METROPOLITAN GOVERNMENT OF NASHVILLE AND DAVIDSON COUNTY

STAFF RECOMMENDATION
1711 and 1713 5th Avenue North
November 20, 2019

Application: Preliminary SP Review for Infill
District: Salemtown Neighborhood Conservation Zoning Overlay
Council District: 19
Base Zoning: R6-A current; Proposed SP
Map and Parcel Number: 08108045700 and 08108045800
Applicant: Preston Quirk
Project Lead: Melissa Baldock, melissa.baldock@nashville.gov

Figure 4 shows staff's recommended changes to the form of two infills facing 5th Avenue North, namely that the second floor line up with the first floor.

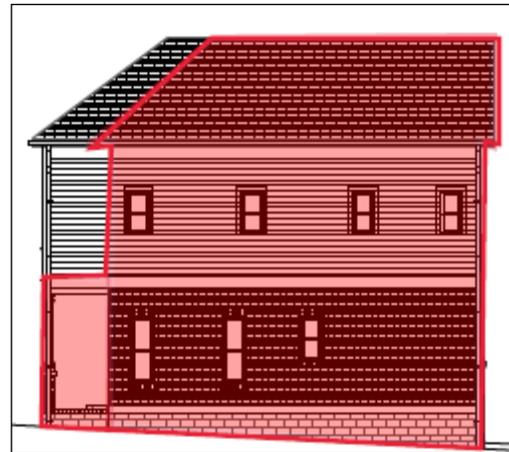
Staff notes that the inset porch with a full second story on top of it is not a form that is found historically in the district. Staff recommends that the second-story wall be pushed back to line up with the wall of the first story so that the porch does not have livable space over it (Figure 4). Staff also recommends that the Juliet balcony, another form not found in the district, be reconfigured to be an uncovered deck on the roof of the revised porch.

With the conditions that the second story wall of the infills facing 5th Avenue North be pushed back to line up with the wall on the first story, and the Juliet balconies be made more substantial to be uncovered decks over the front porch roof, staff finds that these infills meet Sections III.A. and III.B. of the design guidelines.

1 EAST ELEVATION - 5TH AVE N
SCALE: 1" = 10'

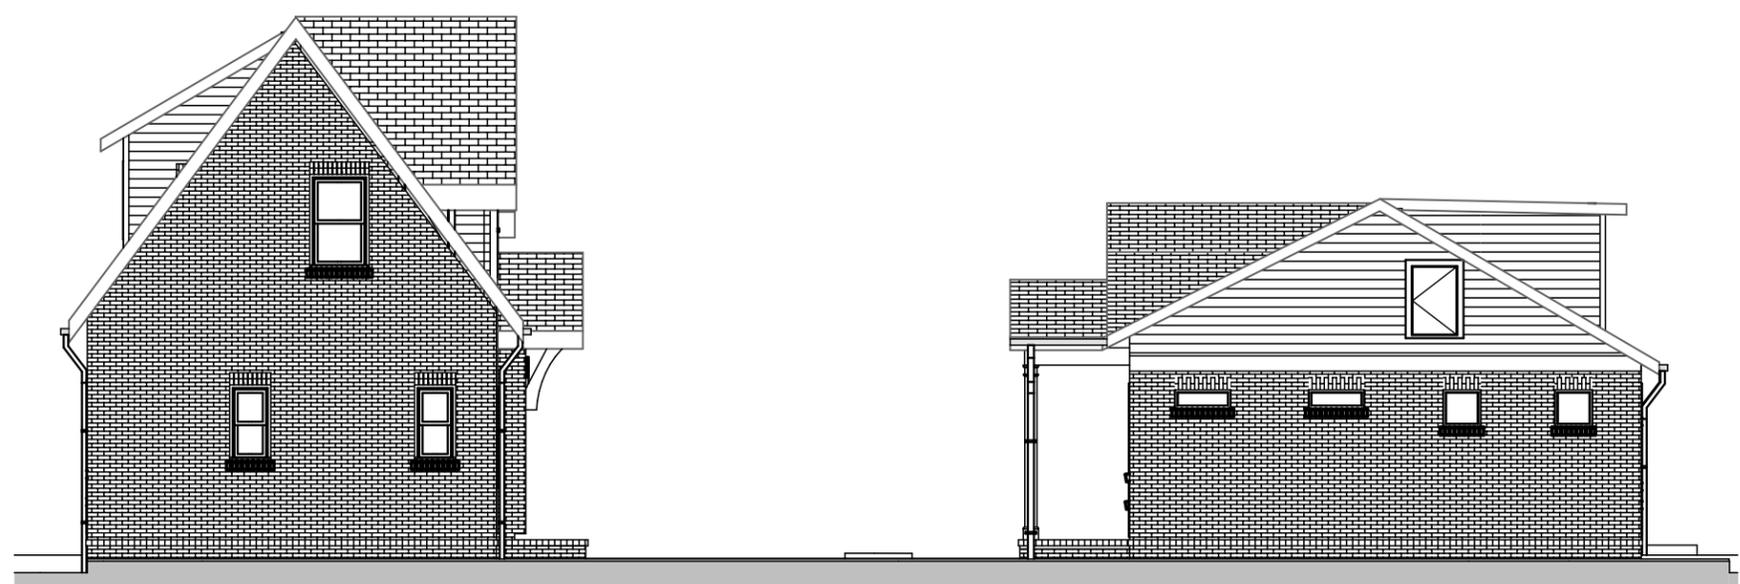
The windows on the proposed addition are all generally twice as tall as they are wide, thereby meeting the historic proportions of openings. The left elevation of the middle infill (Unit 2), on the ground floor, has a length of twenty-five feet (25') without a window or door opening. Staff recommends that at least two window openings be added in this space.

Figure 5. Staff recommends at least two window openings be added to this facade, as shown here.

With the condition that at least two window openings be added to the left elevation of unit two, on the ground floor, and with the condition that if Metro Council approves the SP the applicant return to MHZC with the final designs showing all window and door placements, staff finds the project's proportion and rhythm of openings to meet Section III.G. of the design guidelines.
